UNITED STATES PATENT AND TRADEMARK OFFICE

10/552,229

Wolfgang Dinkelacker

Office Action Summary

**FIG. 15****Claim Rejections - 35 USC § 103**

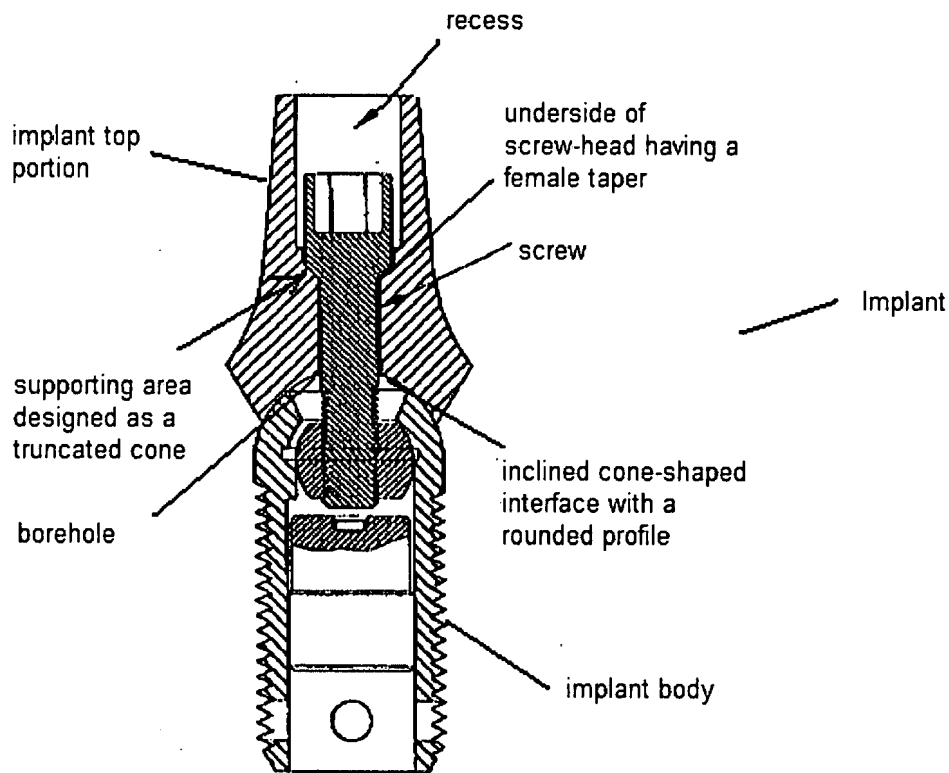
Lustig et al. discloses an implant having: an implant top portion (See Fig. Below) attached to an implant body (see Fig. Below) by means of screw (see Fig. Below); a borehole that surrounds a through-borehole (825 and 915) for connection screw and a recess (see Fig. Below) with a supporting area designed as a truncated cone (Shown in Figure below)(Fig. 1-17) for the screw head; a screw head having an underside that is designed as a female taper shown in Fig. 15 (reproduced in the Figure below); an implant top that is adapted to the profile of the implant body by means of a screw (Column 2, Lines 58-67). It is inherent that the female taper and the truncated cone are brought into close contact when the connection screw is tightened. Lustig et al. further discloses an implant where the interface between the implant body and the implant top portion has a head that runs at a right angle to the longitudinal axis of the implant body (Figs. 15 and 43c); an interface between the implant body and the implant top that has a

profile adapted to a comb shape of the jaw (Fig. 43c); a profile that is inclined toward the buccal side and the lingual side (Fig. 43c); and where the profile toward the buccal side and the lingual side is circularly rounded and also has a bell shape (Figs. 1-17, 43b and 43c). Lustig further discloses a jaw implant where the inclined faces of the buccal side and on the lingual side in the interface area of the implant body form an angle, which is larger than the angle between corresponding inclined surfaces on the buccal side and the lingual side in the interface area of the implant top portion; and where the rounded surface on the buccal side and the lingual side have a smaller radii of curvature in the interface area of the implant top portion than the corresponding rounded surfaces on the buccal side and on the lingual side in the interface area of the implant body (Figs. 15-17, 43b and 43c).

Applicant argues that the undercut of Lustig's screw has a different form and purpose than the female taper of the present invention. However, it has been held that a recitation with respect to the manner in which a claimed apparatus is intended to be employed does not differentiate the claimed apparatus from a prior art apparatus satisfying the claimed structural limitations. See *Ex parte Masham*, 2 USPQ2d 1647 (1987). Lustig discloses the structural limitations of the jaw implant having a recess forming a supporting area in the shape of a truncated cone; and a connecting screw having a female taper at the underside of the screw head in order to mate with the supporting area. This is clearly shown in Figure 15, which is reproduced below.

The figure illustrated above shows the recess having a supporting area designed as a truncated cone and a connection screw having a corresponding female taper that mates with the supporting area.
